# Recall Bulletin

## PRODUCT EMISSION RECALL

**SUBJECT:** Oxygen Sensor Fracture

**MODELS:** 2011-2013 Chevrolet Express  
2011-2013 GMC Savana  
Cutaway Equipped with Gasoline or Liquefied Petroleum Gas (LPG) Fuel Engines

## First and Second Design Sensors

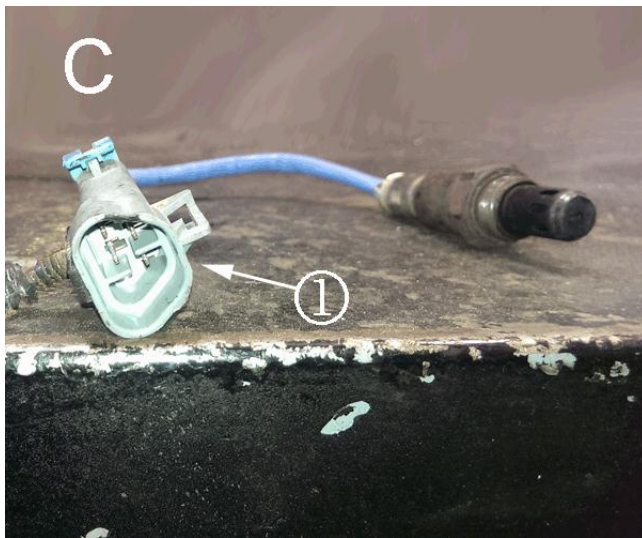
(A) 2011 through early 2013 OE production first design male connector. Replace the part with a second design part with a male connector, P/N 12637297. (B) 2011 through 2013 second design service part, P/N 12637297. Do NOT replace this part unless the part has failed. If the part has failed, replace the part with the second design part with a male connector, P/N 12637297.

(C) This is the second design 2013 production sensor with the female plug (1). The sensor and plug change was made to indicate the new design. Do NOT replace this sensor, P/N 12656071, unless the part has failed.

3. Determine if a first design (A) or second design (B) heated oxygen sensor is installed using a light and mirror.
  - If a second design (B), P/N 12637297, P/N 12656071 heated oxygen sensor is currently installed, no further action is required. Lower the vehicle. Refer to *Lifting and Jacking the Vehicle* in SI.
  - If a first design (A), P/N 12612571, heated oxygen sensor is in place, remove the sensor and replace it with a second design heated oxygen sensor. Refer to *Heated Oxygen Sensor Replacement –Bank 2 Sensor 2* in SI and *Heated Oxygen Sensor Replacement –Bank 1 Sensor 2* in SI.
